PRELIMINARY OVERALL AREA DEVELOPMENT PLAN FOR ESCONDIDO SUBDIVISION

URS	800 ISOM ROAD, SUITE 102 SAN ANTONIO, TEXAS 78216	REVISED PRELIMINARY OVERALL AREA DEVELOPMENT PLAN FOR ESCONDIDO SUBDIVISON	SHEET NO. 1 OF 1 SHEETS FILE NO. 8603801

RE: Escondido POADP
File # 85-11-63-28
Revised: 8/19/86

☐ Preliminary Plan
Re: Escondido ☒ P.O.A.D.P.
File #: 85-11-63-28

preliminary overall area development plan

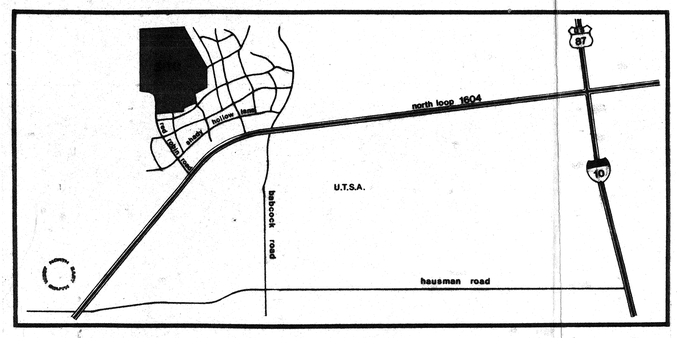
(X) Comments: Staff concurs with the 60' collector with 44' of paving and the overall plan. However, there is a concern to the 15 lots fronting onto said collector. Staff suggest that an alternative design be submitted to discourage lots from having direct access to the collector.
